# THE MARINE WORKS (ENVIRONMENTAL IMPACT ASSESSMENT) REGULATIONS 2007 (AS AMENDED) MARINE LICENCE APPLICATION CML2365 – HYNET CARBON DIOXIDE TRANSPORTATION AND STORAGE PROJECT – OFFSHORE

**Applicant response to Request for Further Clarification dated 11 October 2024.**

Figure 3.1: Currently anticipated programme for vessel movements and platform works at Hamilton Main

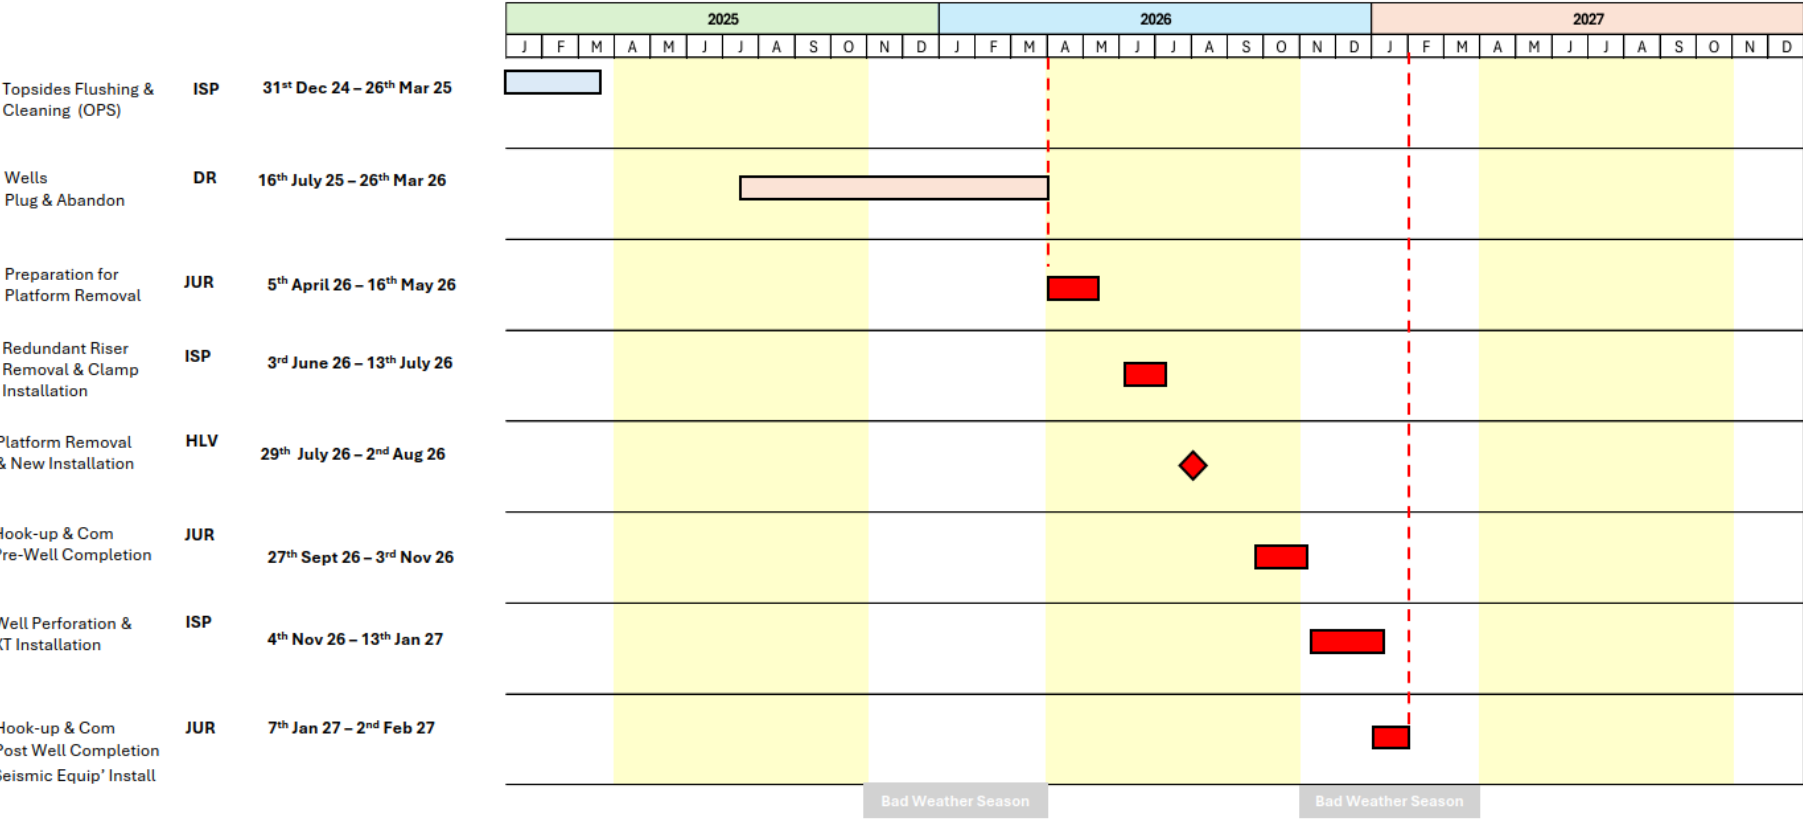
A number of comments from the ANCB refer to required timing restrictions. Please provide a table to clarify timing restrictions commitments at the different stages and locations of the project, as ANCBs consider these necessary to rule out adverse effect on site integrity. Please also consider timing restrictions to mitigate impact to fish features, as requested by NRW A.

**Figure 3.1** shows that the "platform removal & new installation works" for the Hamilton Main platform are currently scheduled to take place during **29<sup>th</sup> July 2026 to 2<sup>nd</sup> August 2026**. This period of works includes around one day for the lifting of the existing topsides off its jacket and onto the transportation barge. Another day will be required to prepare the new risers and J-tubes to receive the new topsides, which will then take another day to be lifted into place from the transportation barge. This means that the existing jacket will be without a topside for a very short period through carrying out seamless, sequential removal and installation operations.

**Figure 3.5b: Currently anticipated programme for vessel movements and cable Installation 2026**

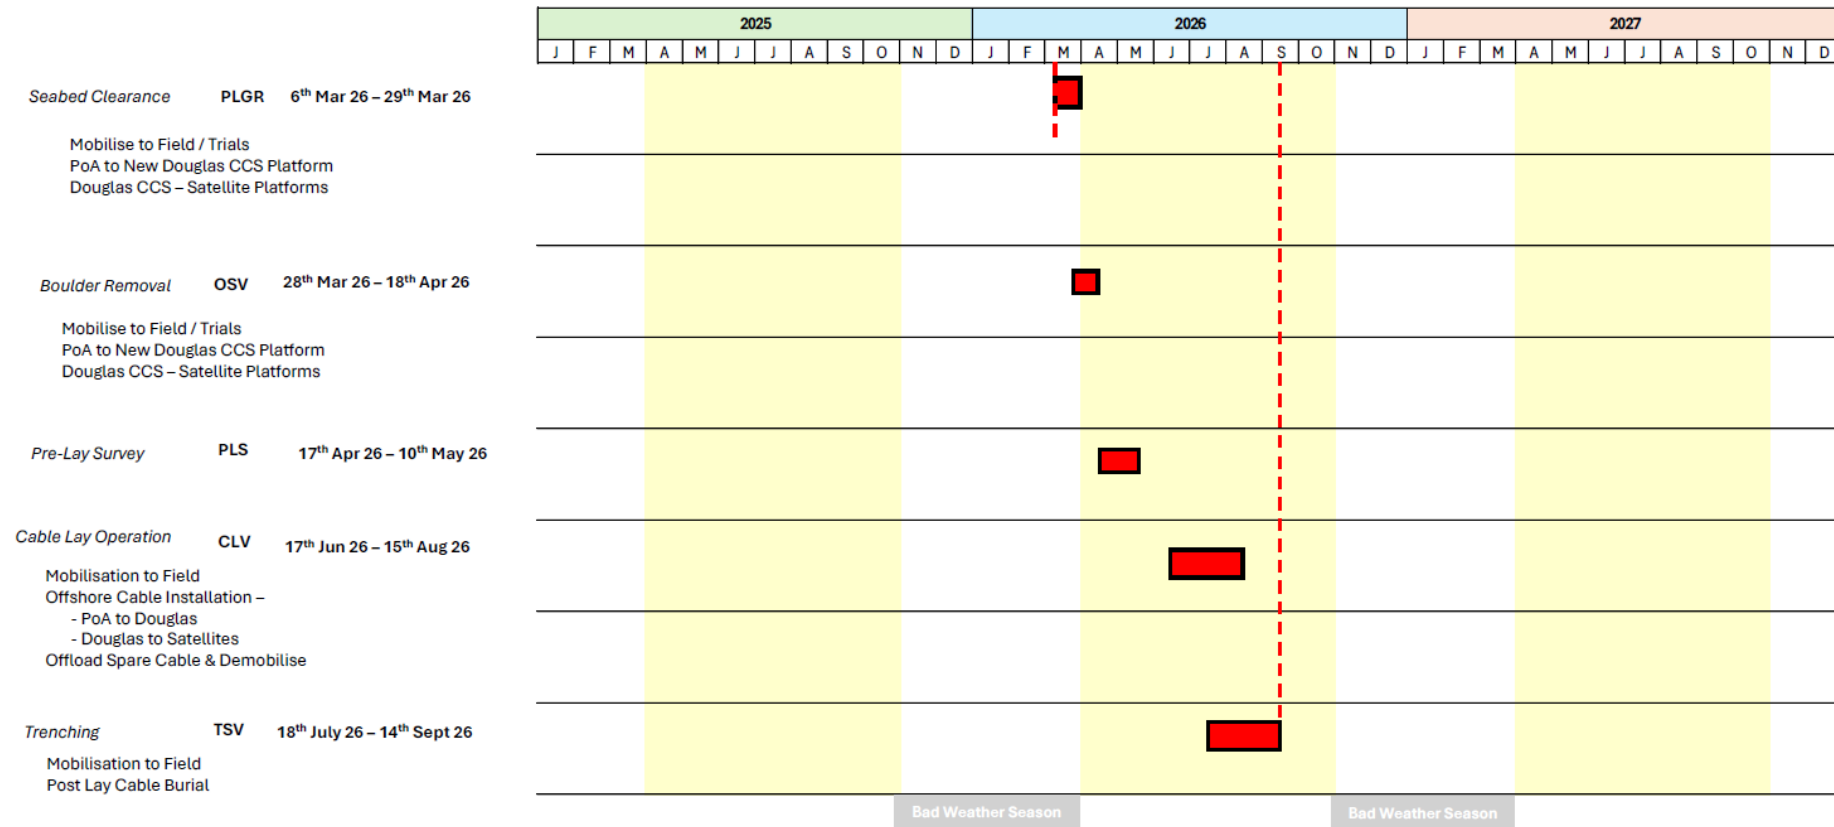
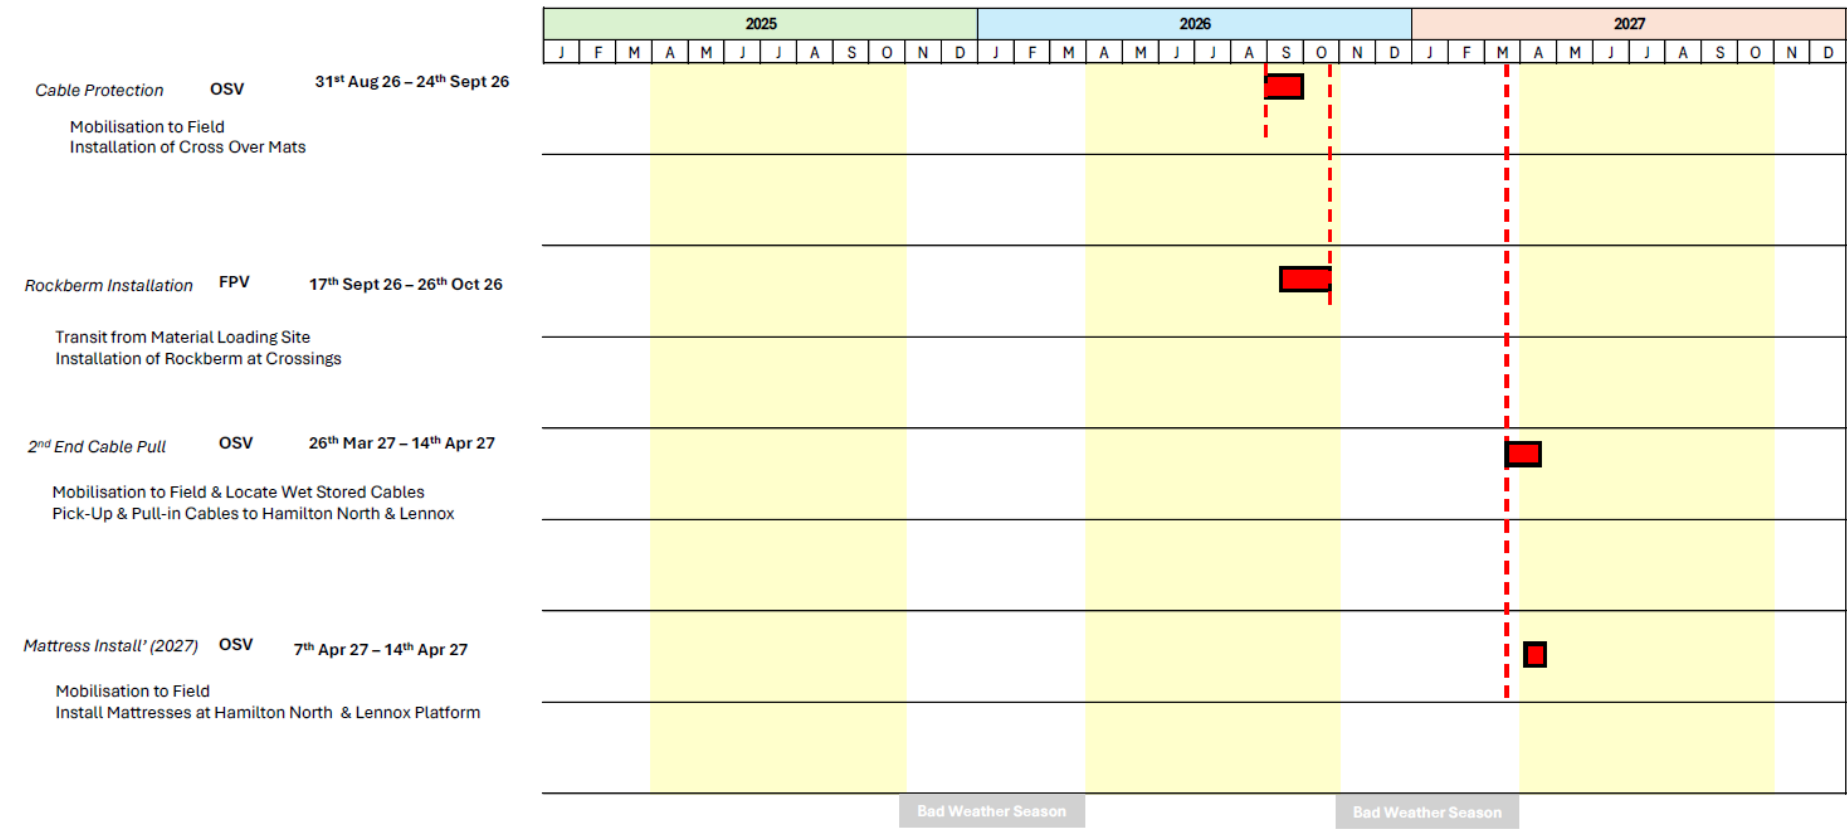
**Action required:** Please clarify timing restrictions and confirm the plans in which these timing restrictions are proposed to be secured.

**Figure 3.5a to 3.5c** include the offshore geophysical and geotechnical surveys from **May to June 2025**. The cable installation operation with a Cable Lay Vessel (CLV) is planned to mobilise from **June to August 2026** from POA to new Douglas, and from new Douglas to the satellite platforms, including all the preparatory works (e.g. rollers installation), mobilisation of the CLV and pulling out the cable. All cable protection and mattress installations are scheduled in **summer 2026 and 2027** avoiding the winter bad weather.

The Applicant has created mini programmes for the cable laying and inter-tidal works, which are presented above, in response to **Question 3** in **Figures 3.5a to 3.5c**. The mini-programmes show this work is planned to mobilise from **June to August 2026**. The cable lay activities will start with the preparatory works (e.g. rollers installation), mobilisation of the CLV and pulling out the cable.

**Figure 12.1: Typical Schematic Layout of Concrete Mattress Protection at Cable Crossing**

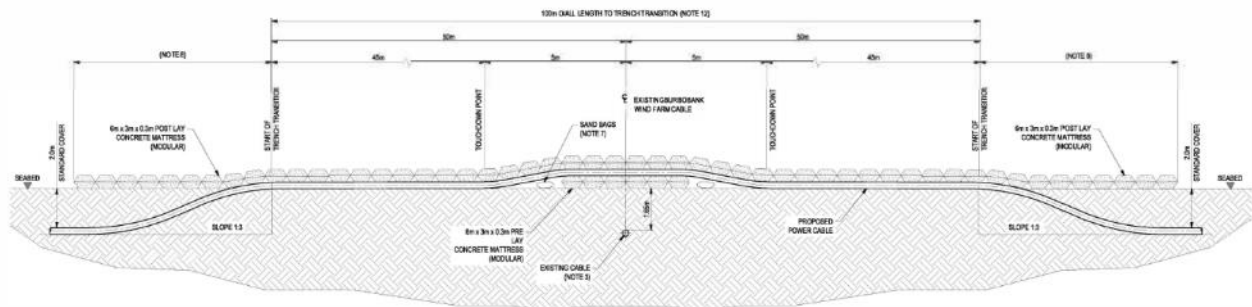
**Action required:** Please provide further clarification on secondary impacts of benthic habitats due to scour protection and changes to physical processes.

In such cases the design of the cable crossing reduces the potential impacts of physical processes using layered protection, which gradually changes in height, as illustrated in **Figure 12.1** and **Figure 12.2**. Each layer of the modular post lay concrete mattress is 0.3 m in height. At the approach to the crossing, there will be a single layer of mattresses which then overlays the cable as it emerges from the bed and is surface laid. The cable will then be laid over a single layer of mattresses placed on the bed at the crossing point. This is then covered with either a single layer of mattresses, or rock.

For crossings PoAX-1, and PoAX-2 the concrete mattress protection as shown in **Figure 12.1**, the distance of the touchdown points either side of the crossing is circa 5 m. Therefore the 0.8 m berm height occurs for a limited distance <10 m and for most of the crossing the obstruction on the bed is between 0.3 m and
